**CITY OF RAMSEY LAND USE APPLICATION  
TECHNICAL REVIEW FILE**

<b>DATE</b>	JULY 27, 2017	<b>PROJECT ADDRESS</b>	CORNER OF CENTER STREET NW AND 146 <sup>TH</sup> AVENUE NW
<b>PROJECT. TITLE</b>	FINAL PLAT AND SITE PLAN REVIEW		
<b>ESCROW #</b>			
<b>DEPARTMENT:</b>	Community Development: Planning Division (Zoning Code)		
<b>TECHNICAL REVIEWER:</b>	Name: Eric Maass, Consultant Planner Phone: 763-576-4306 Email: <a href="mailto:EMaass@wsbeng.com">EMaass@wsbeng.com</a>

**General.** The purpose of this portion of the review is to assess the submitted site plan application for Greenway Terrace. The associated plans were prepared by UrbanWorks Architects, BKBM, and Damon Farber Associates and are dated June 1, 2017.

<b>DATE</b>	JUNE 27, 2017	<b>PROJECT ADDRESS</b>	146 <sup>TH</sup> AVENUE AND TRAPROCK STREET
<b>PROJECT. TITLE</b>	GREENWAY TERRACE - AEON		
<b>ESCROW #</b>			
<b>DEPARTMENT:</b>	Engineering		
<b>TECHNICAL REVIEWER:</b>	Name: Leonard Linton Phone: 763 433-9834 Email: llinton@ci.ramsey.mn.us

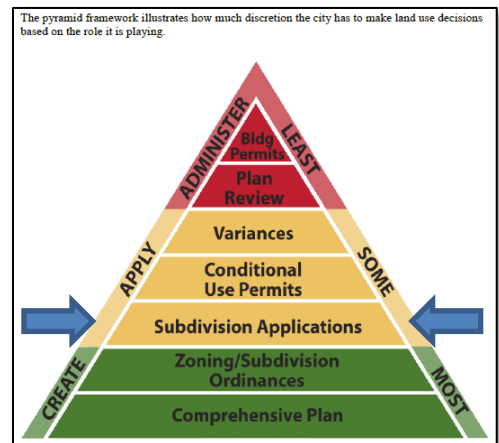
1. Revision of the Final Plat sheet so that it identifies the City of Ramsey as the recorder of the plat.
